ARBORICULTURAL ADDENDUM

Response to Wokingham Borough Council queries 1–12

Site	Conway Park (formerly Stowdes Estate)
Planning application	213610 – Estate Management Buildings
Purpose	Addendum to the approved / submitted arboricultural information
Author	Practicality Brown
Date	September 2026
Status	For submission to Wokingham Borough Council

Supplementary addendum to the Estate Management Building Block Plan (Drwg no. 0002, issue PL1. Oct 2017)
Revised protection measures around retained trees.

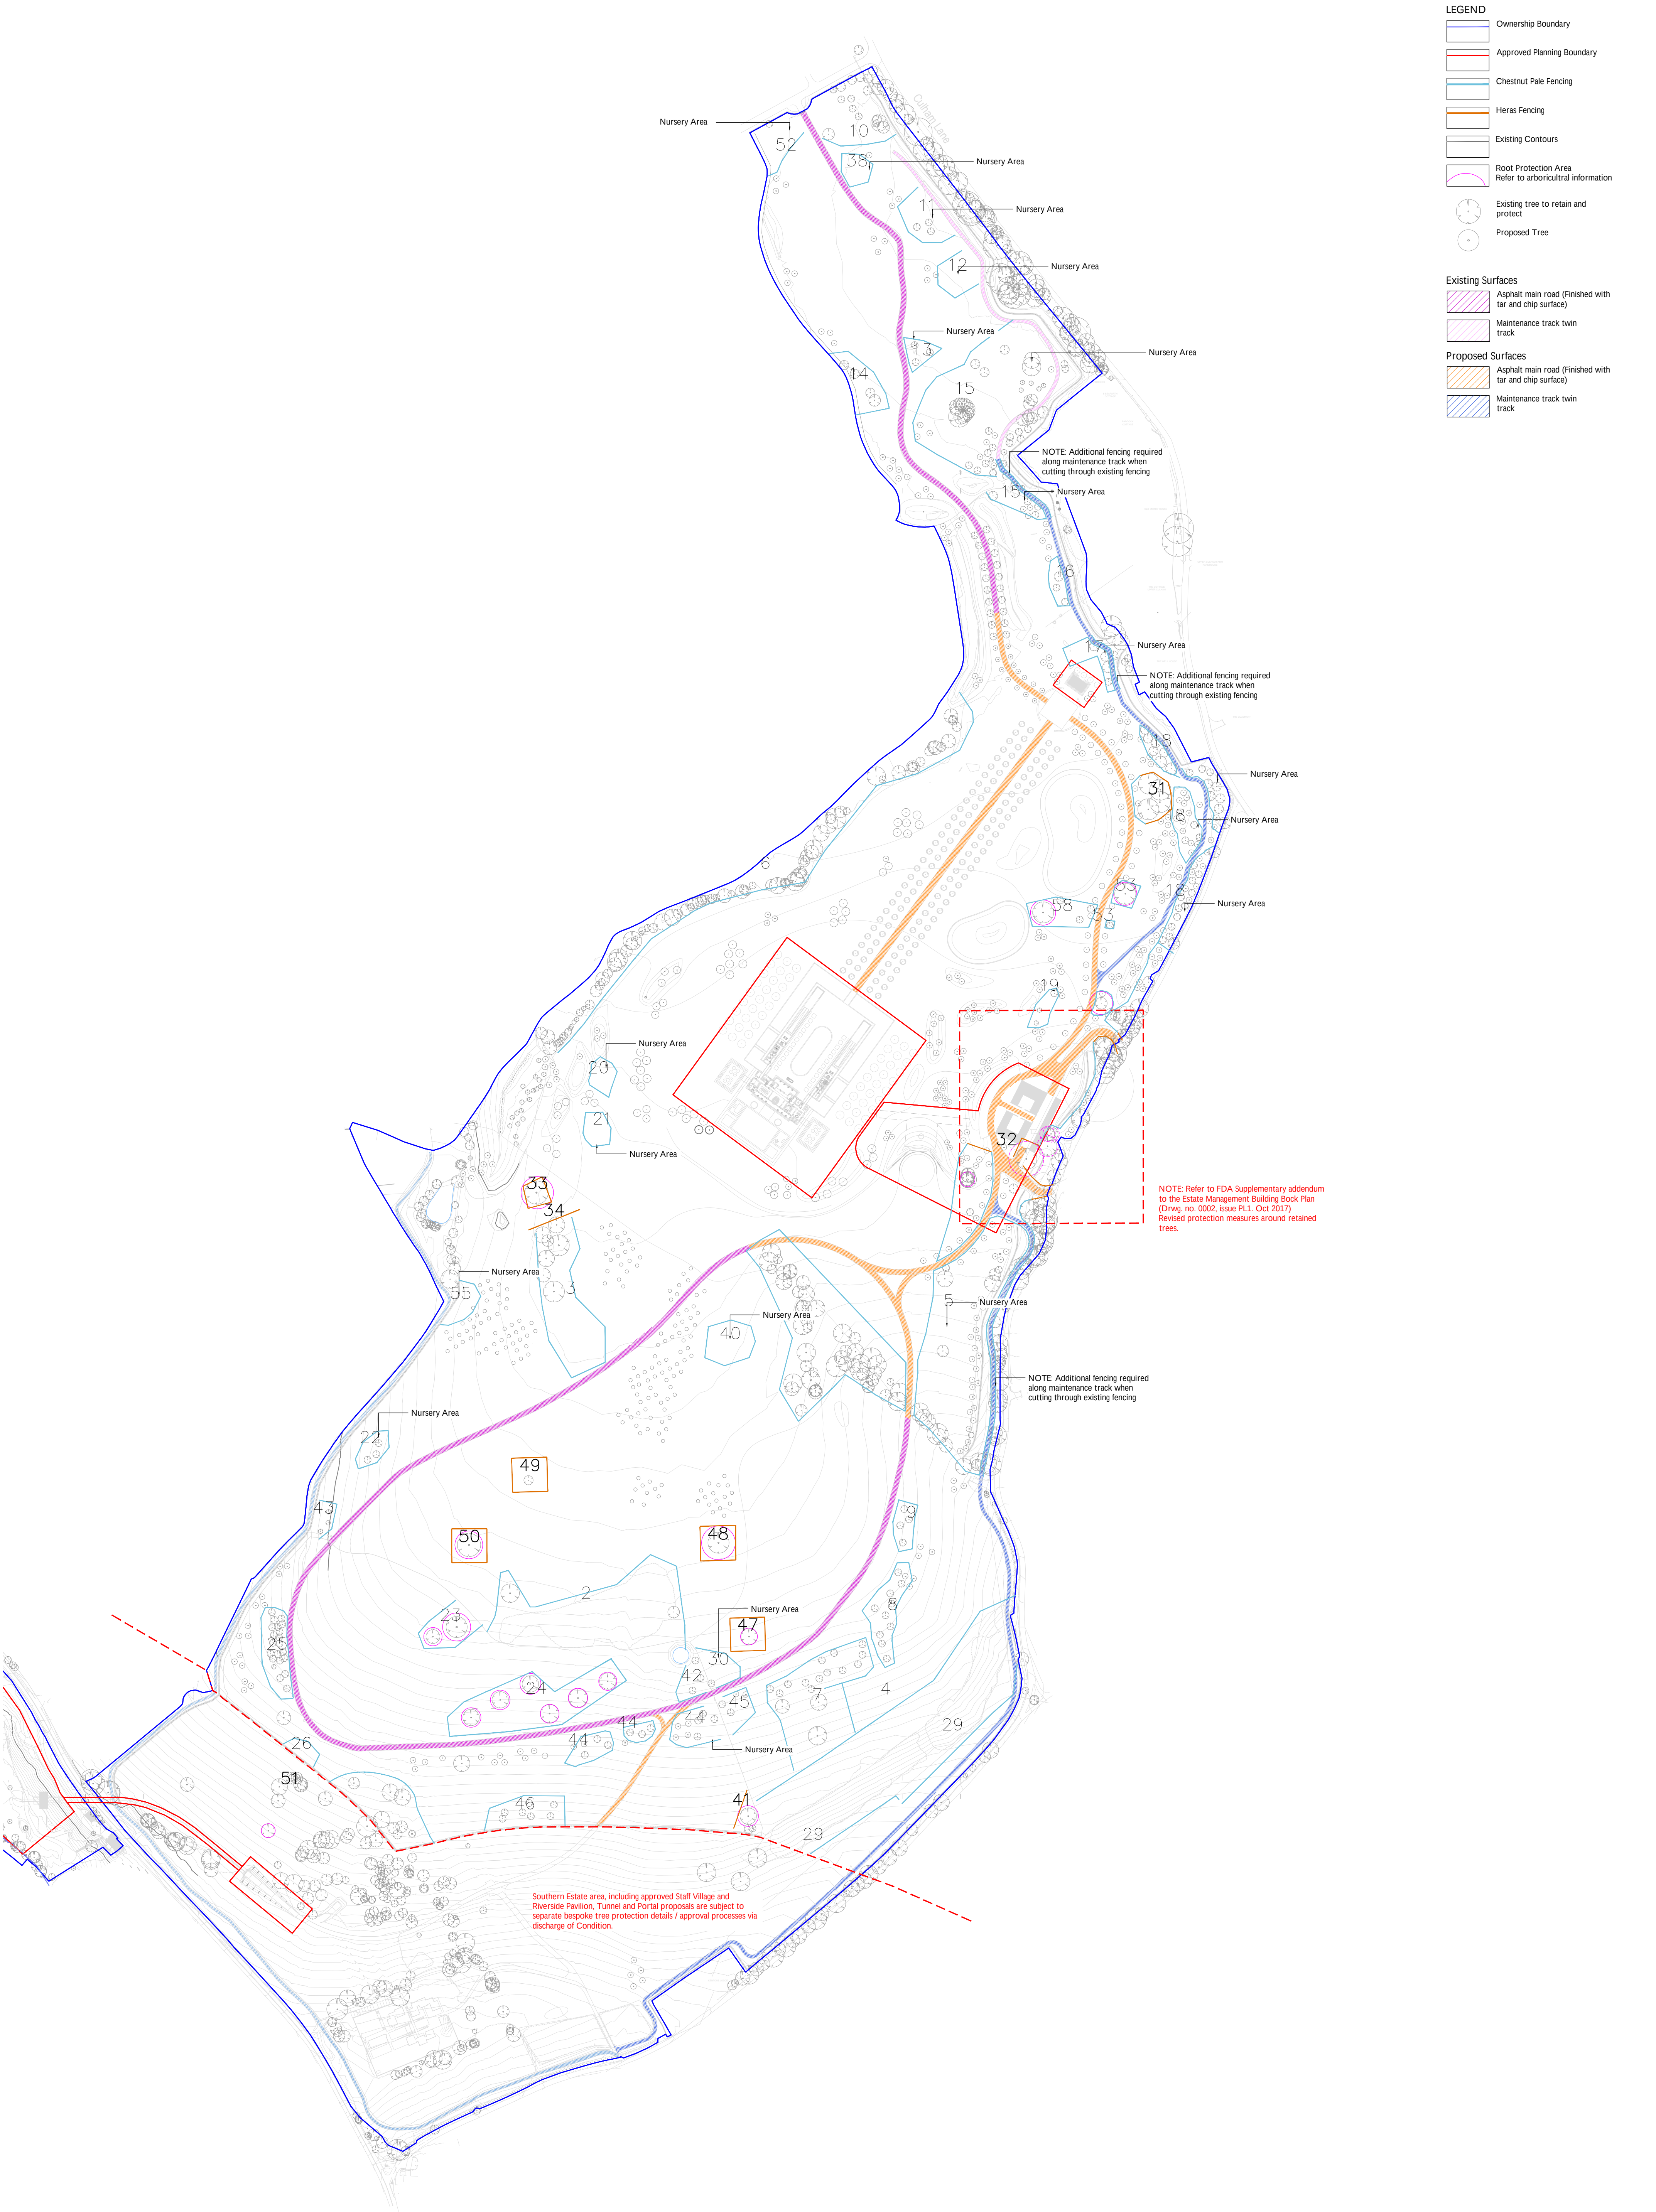
Full tree protection fencing will need to be indicated for the existing tree belt to the east of the proposed estate building as shown on the Fulford-Dobson drawing

Tree protection fencing is to be installed in this area as set out within the original FDA specification (attached to this addendum). This shows a protection zone (shaded purple) between the development site and the existing tree belt and hedge to the east.

The FDA plan also specifies a no-dig construction zone (shaded brown) to cover construction of the access track surfacing and the single storey open fronted car-port building. This is to ensure that the root protection areas of principally T32 (Cat A) large Oak, and also T25 and 26 (Cat C) are treated sensitively.

In order to ensure this, the No-Dig Zone, would be undertaken under supervision using Cellweb for surfacing and RADIX ground screws for the building structure. Further detail is provided under point 7 below.
